**HOWELL TOWNSHIP PLANNING COMMISSION
REGULAR MEETING**

A. Old Business:
- B. New Business:
 1. Kory Leppek, PC2025-01, Parcel # 4706-20-100-027, 4640 W. Grand River Ave.
 Preliminary Site Plan Review
 2. Renewable Energy Ordinance - Discussion

Site Plan Review For Howell Township, Michigan

Applicant:	Kory Leppek
Project Name:	Leppek Landscapes
Plan Date:	December 16, 2024
Location:	4640 W Grand River
Zoning:	Industrial Flex Zone (IFZ)
Action Requested:	Preliminary Site Plan Approval

LANDSCAPE PLAN

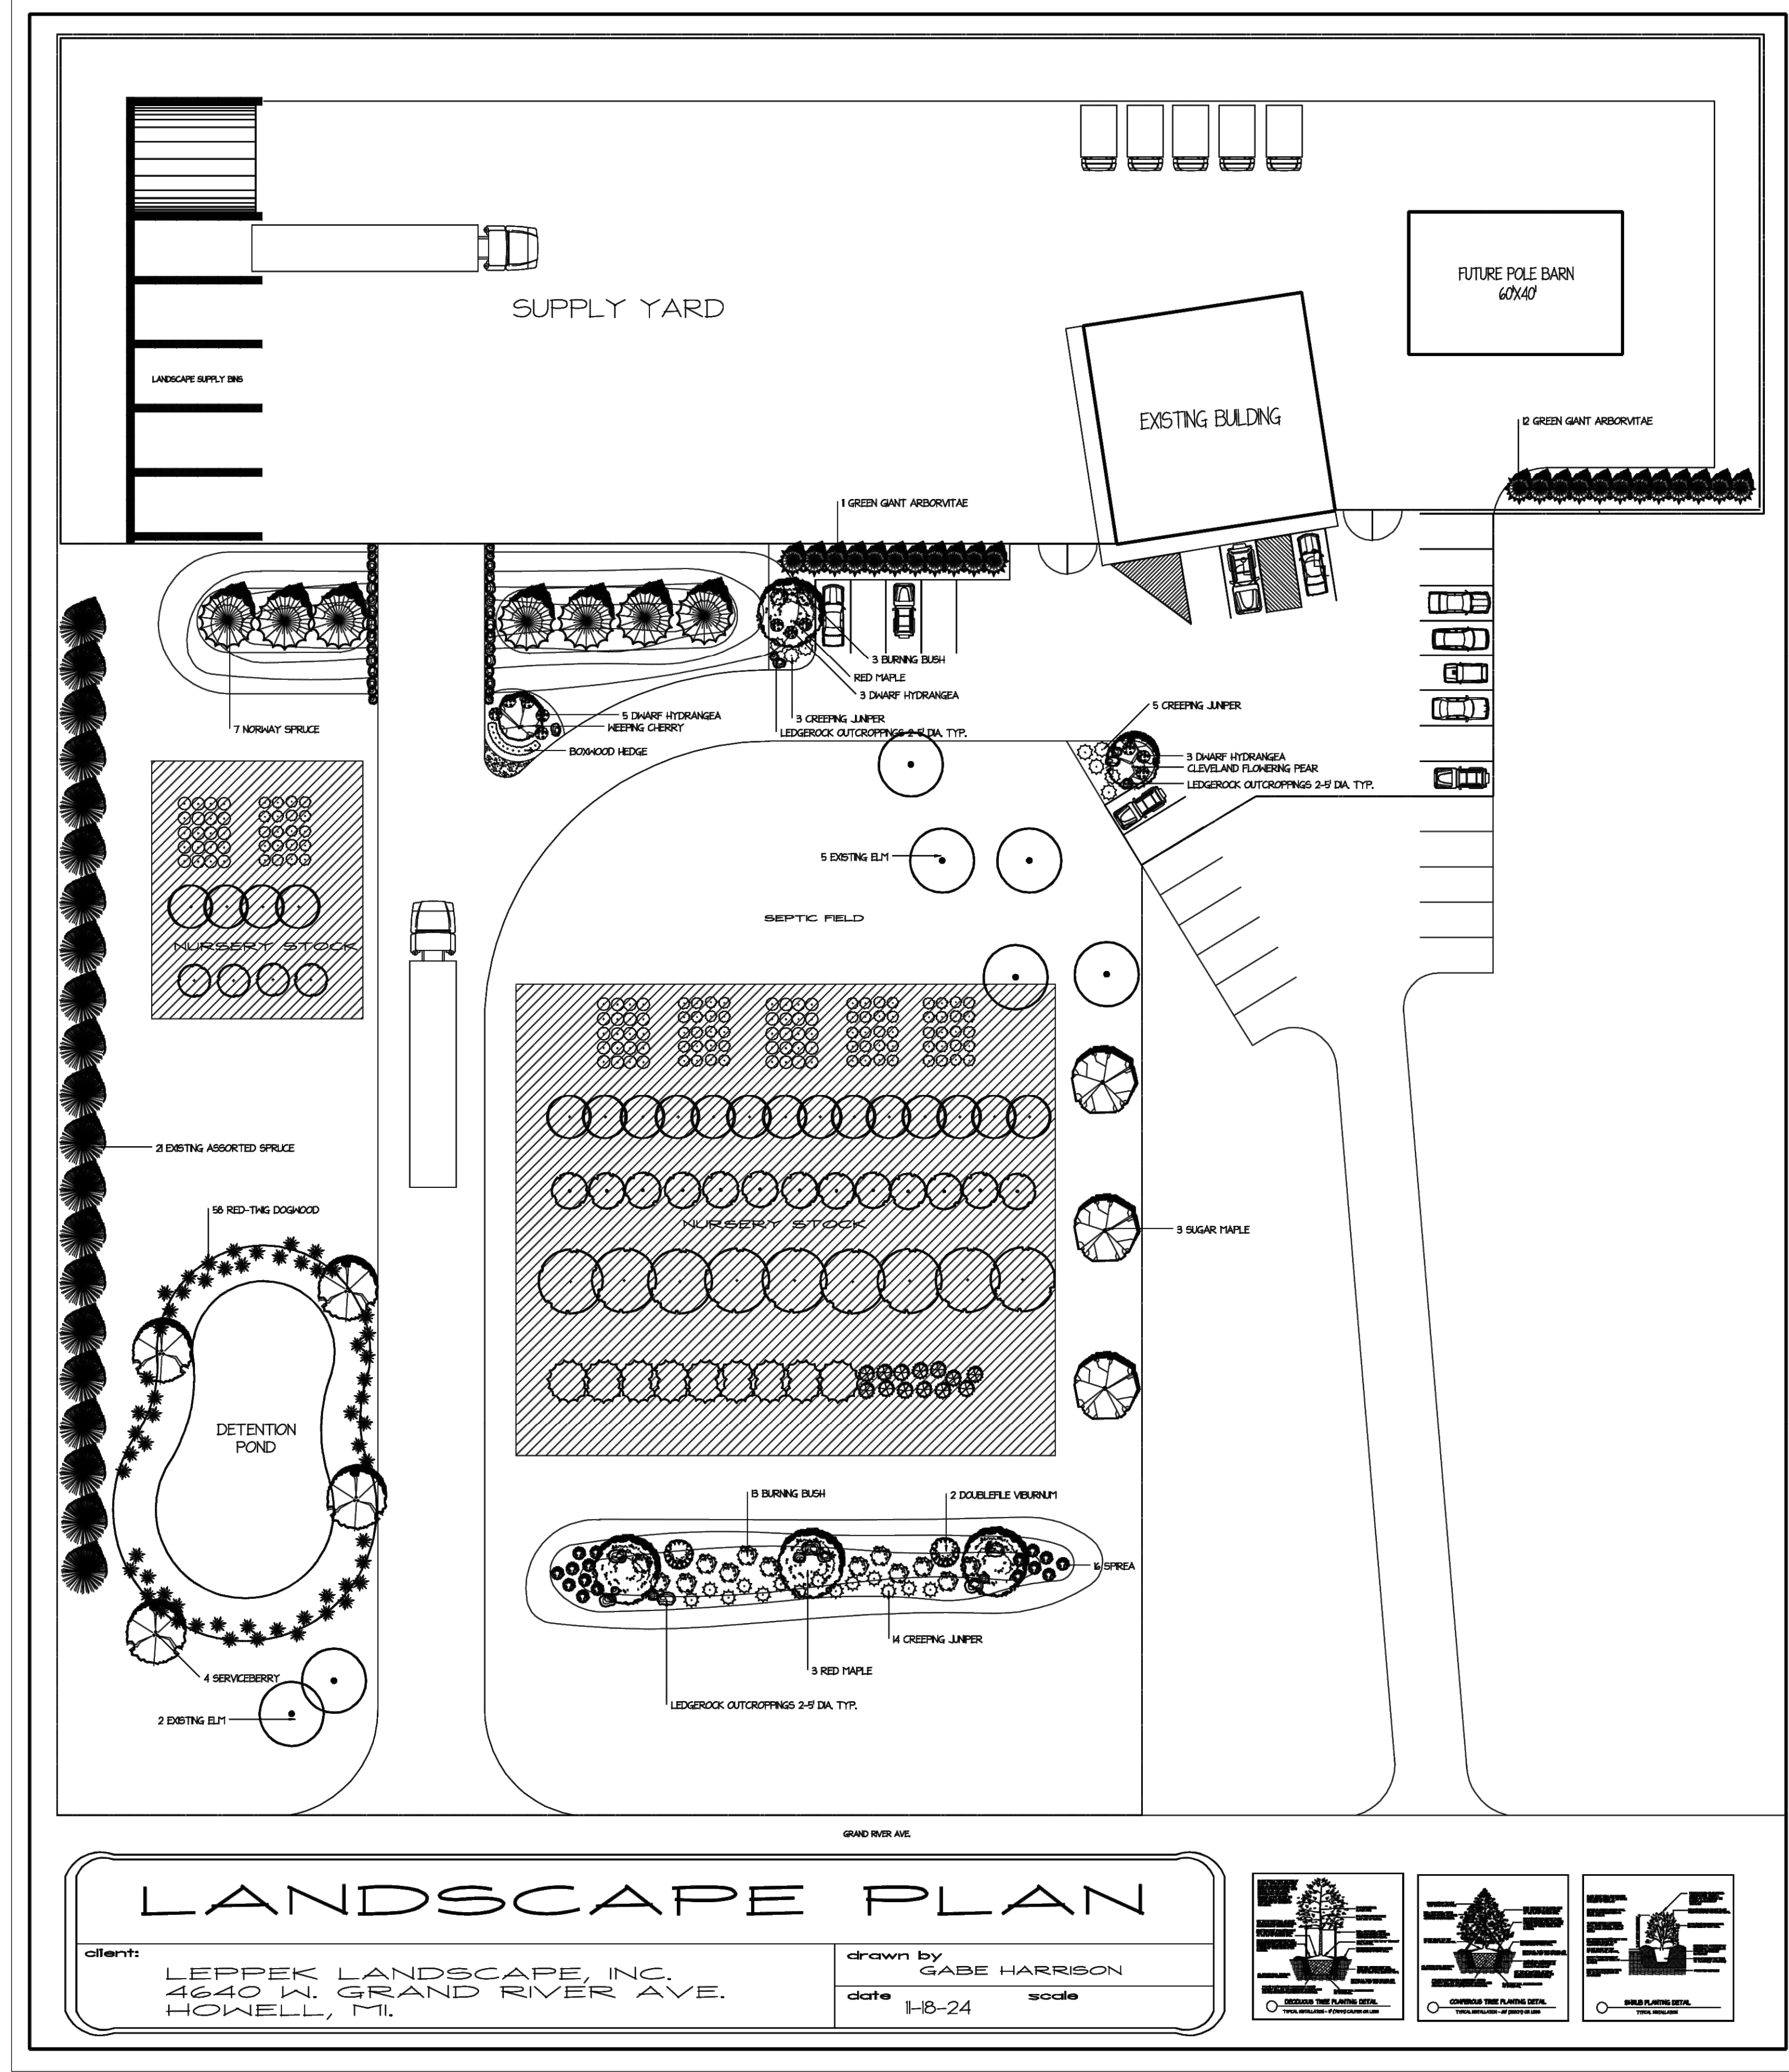
The applicant has provided a landscape plan, as shown in the following tables. The plan does not indicate that the unpaved portions of the site will be planted with grass, ground cover, shrubbery, or other live plant materials. Section 28.02.A.1 states that grass areas in the front yard of all nonresidential uses shall be planted with sod, hydroseeding, or mulched or covered seeding.

The submitted landscaping plan does not show the location, name and size of trees, shrubs, vines and ground covers to be planted on-site, including plantings related to buildings and structures, buffer areas and screenings, including detailed cost estimates for each item of construction as required per Section 20.06.B-2.4. For the purpose of this review, lot information is taken from Sheets C1.0, C3.0, and LP-1.

13. Include dimensional information for detention pond on sheet LP-1.
14. Provide 11 additional shrubs along W Grand River Ave.
15. Applicant shall provide a professionally sealed lighting plan.

The landscaping plan (Sheet LP-1) includes an additional drive connecting the west drive to the employee overflow parking; however, this connection is not shown on any other plan sheets. The site layout should be consistent throughout the plan set. Additionally, if the west drive provides access to the parking area, it must be hard surfaced with asphalt or concrete. We recommend that the drive be hard surfaced regardless of the layout.

Items to be Addressed: 1) Confirm that grass areas in the front yard of all nonresidential uses shall be planted with sod, hydroseeding, or mulched or covered seeding. 2) Provide required berm to screen new parking area parking. 3) Provide landscaping table showing the location, name and size of trees, shrubs, vines and ground covers to be planted on-site, including plantings related to buildings and structures, buffer areas and screenings, including detailed cost estimates for each item of construction. 4) Include dimensional information for detention pond on sheet LP-1. 5) Provide 11 additional shrubs along W Grand River Ave. 6) Planning Commission to determine additional landscape screening requirements per conditional rezoning agreement.
